METROPOLITAN GOVERNMENT OF NASHVILLE AND DAVIDSON COUNTY

STAFF RECOMMENDATION
622 Fatherland Street
April 15, 2015

Application: Demolition—outbuilding; New construction—Detached accessory dwelling unit; Setback determination

District: Edgefield Historic Preservation Zoning Overlay

Figure 2 (left) is a picture of the existing outbuilding and Figure 3 (right) is the 1957 Sanborn map that shows that the exiting outbuilding had not yet been constructed.

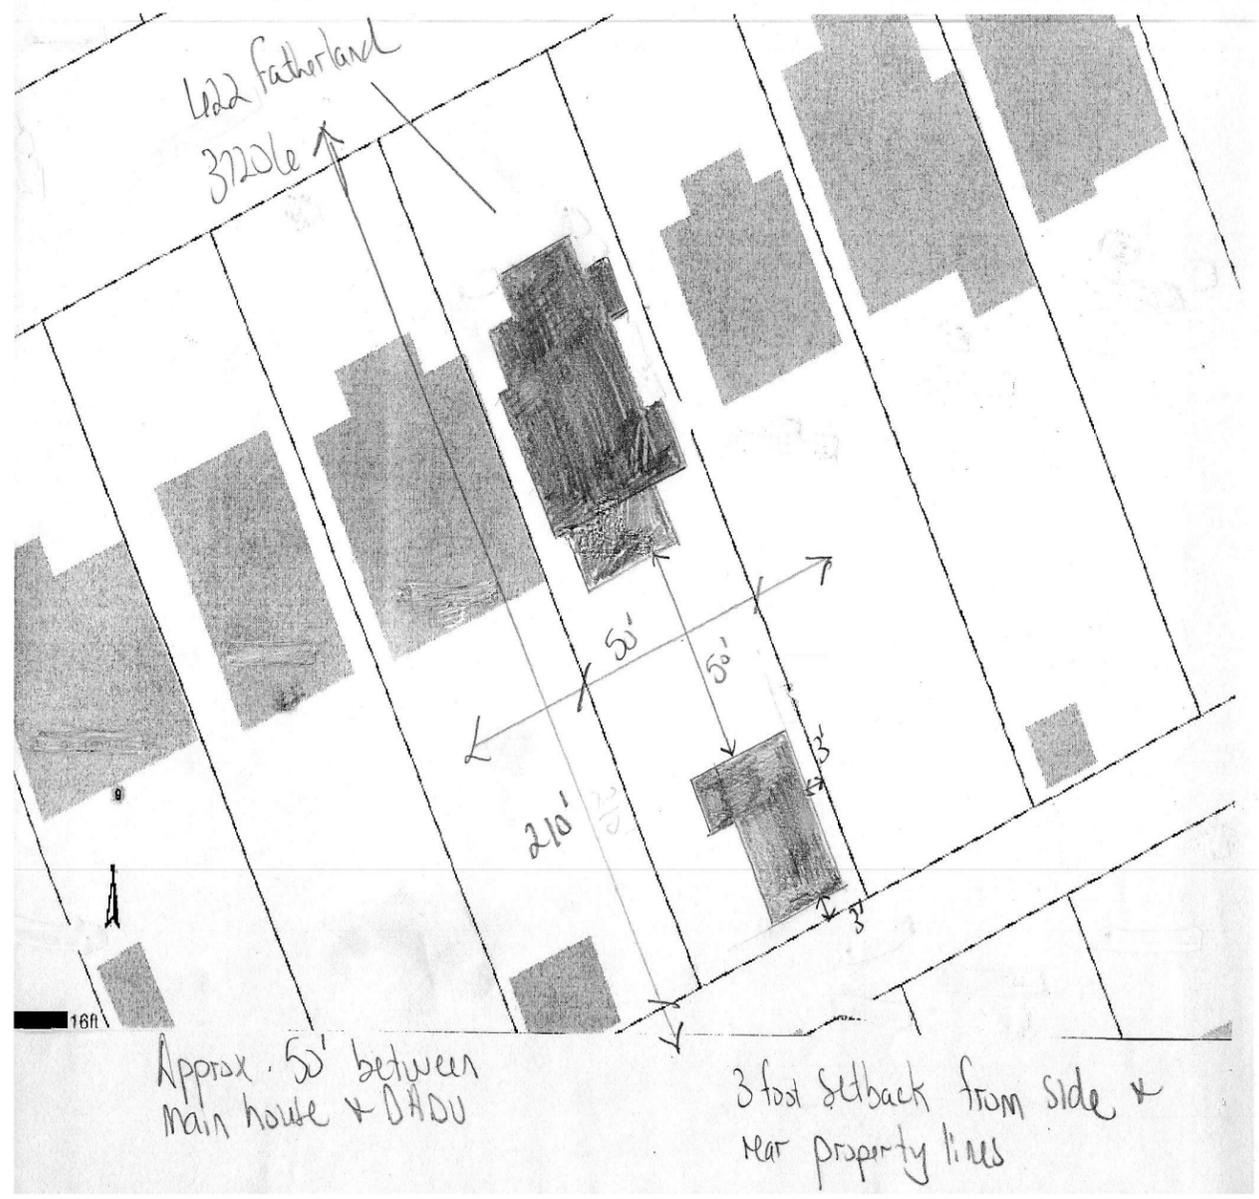
Demolition. The applicant is proposing to demolish an existing outbuilding (Figure 2). The exact date of construction for the outbuilding is unknown, but it is outside of the period of significance for the district. It was constructed after 1957, as it does not appear on the Sanborn map from that year (Figure 3). Its materials, lack of architectural details, and design do not contribute to the historic character of the house or the Edgefield neighborhood. As such, staff finds that its demolition meets Section V.2. for appropriate demolition and does not meet Section V.1. for inappropriate demolition .

North Elevation

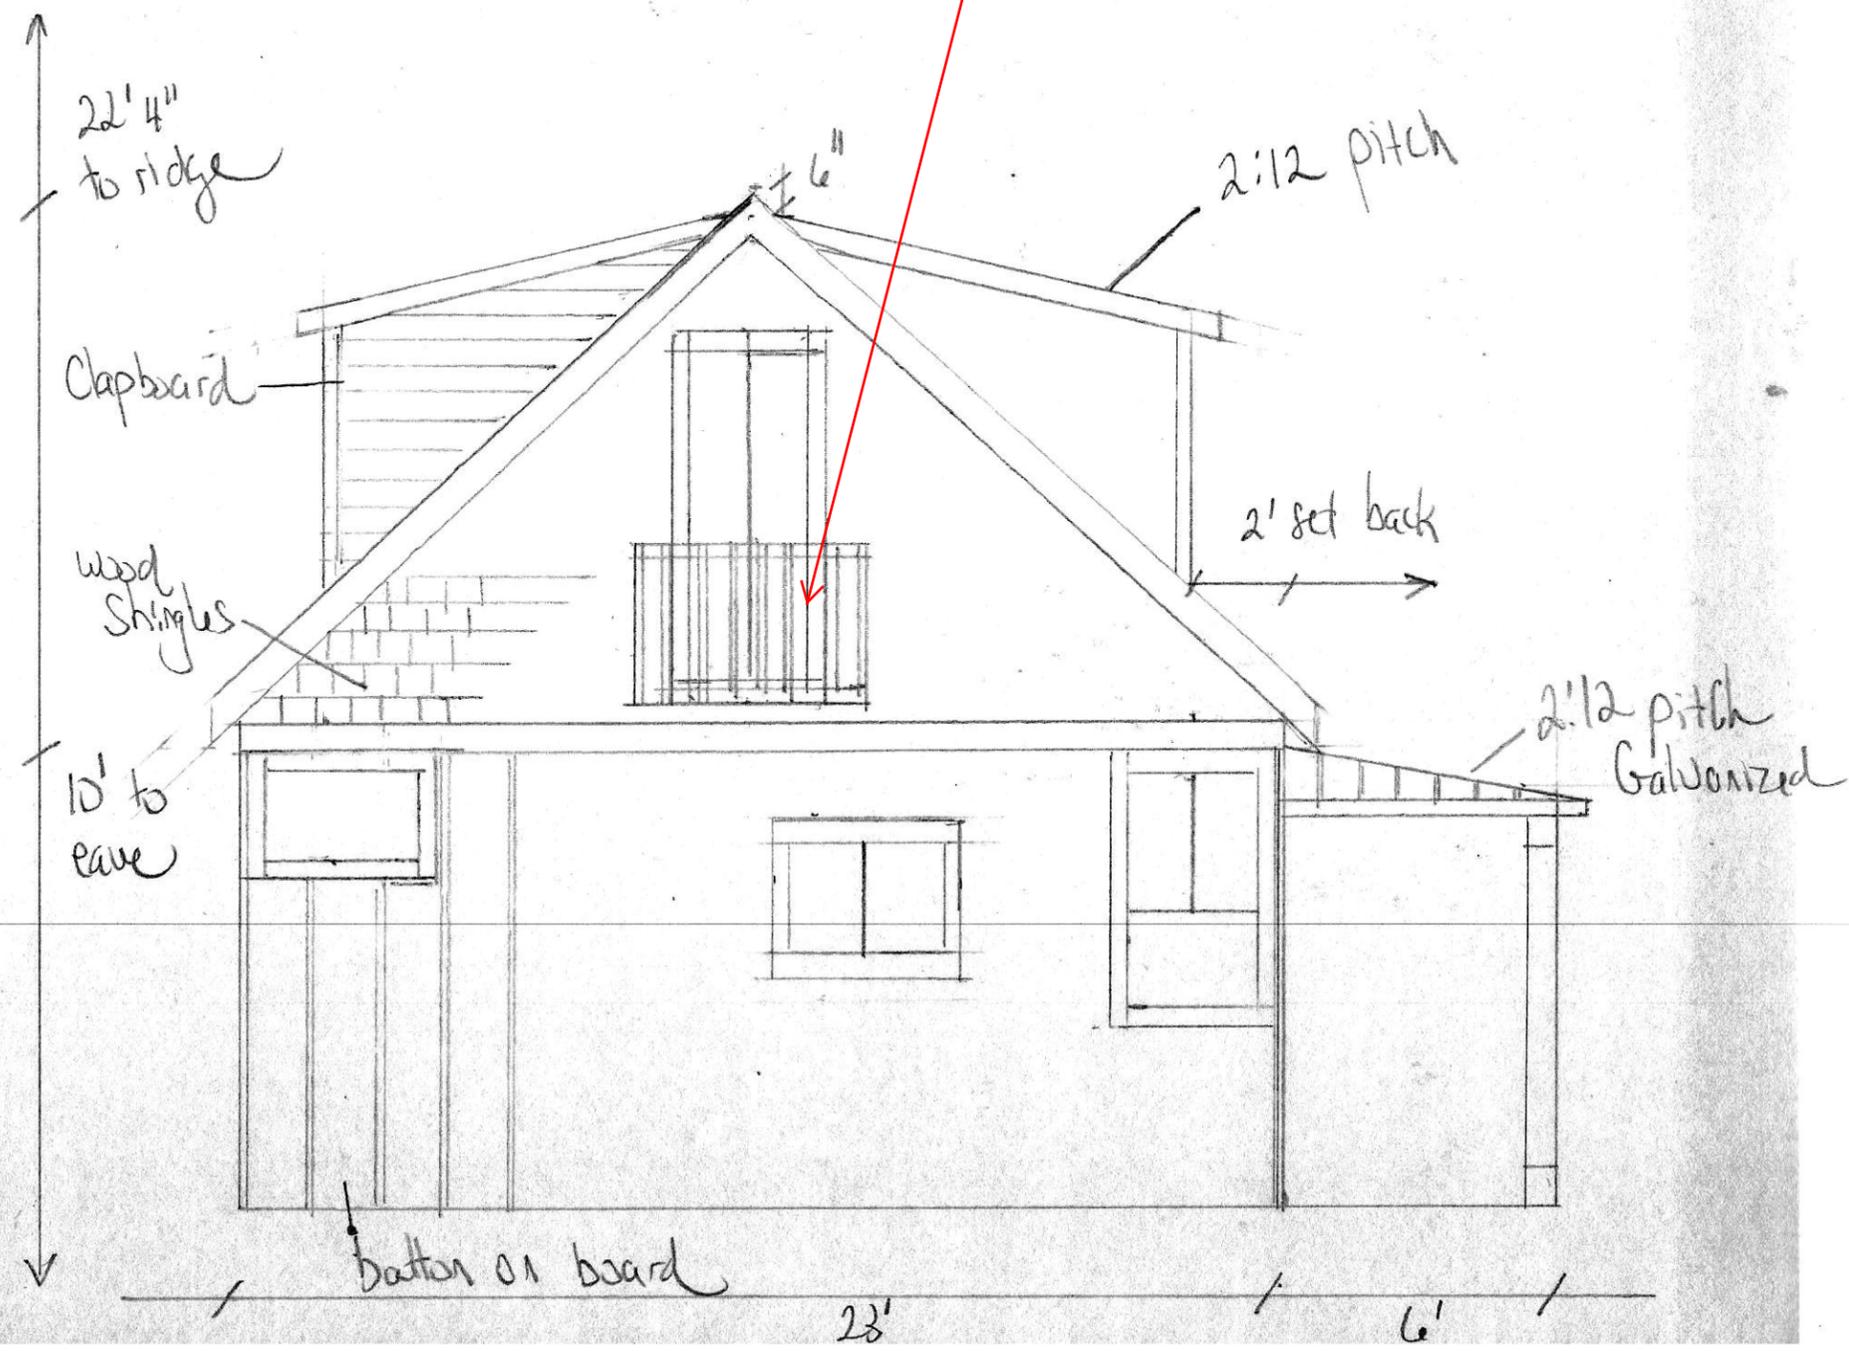
MH2C Note: this is a railing that will not protrude more than 6" from the facade
